**FT-102 Modification**  
**Modification to improve the transceiver performance**

This modification will provide better switching on the transmit and receive functions.

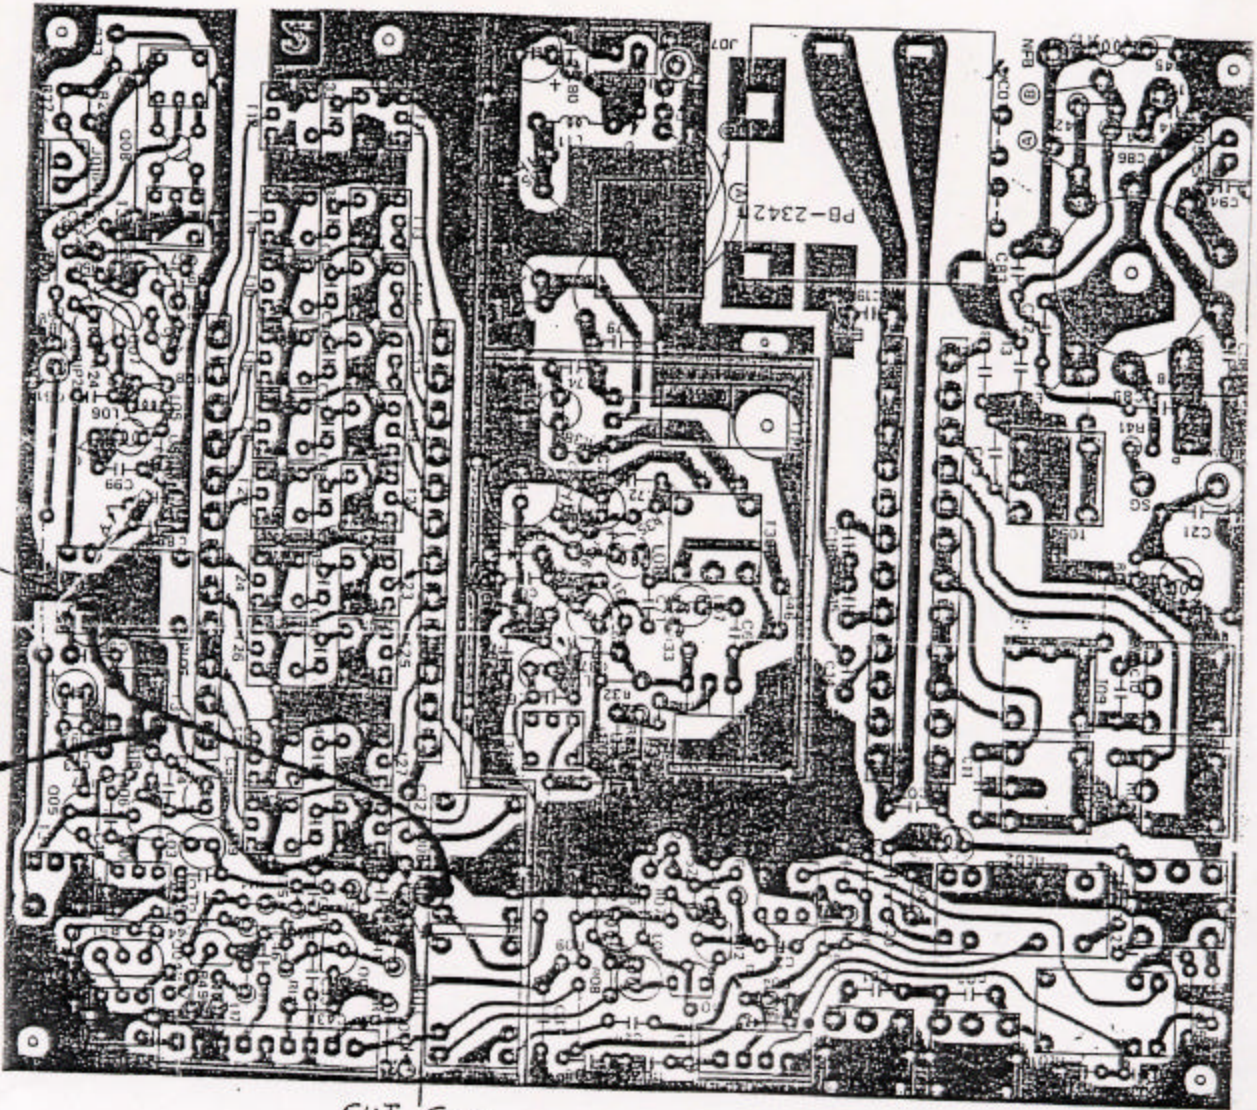
1. Remove the top and bottom covers.
2. Remove the four (4) screws from the AF unit, also remove the shield cover.
3. Remove the defective relays from the RF unit.
4. Install new relays to the RF unit.
5. Referring to Figure-1, cut the foil and install the jumper wire.
6. Replace the shield cover, AF unit top cover and bottom cover. The modification is now completed.
7. See below for the required parts.

CUT FOIL

ADD WIRE

CUT FOIL

OLD	NEW
RL01	M1190002	M1190096
RL02	M1190006	M1190006
RL03	M1190002	M1190096
RL04	M1190037	M1190096
RL05	M1190037	M1190096

*Replaced by:*  
M1190032  
OMRON G2E-182P-M  
\$3.00 each from Yarsu USA
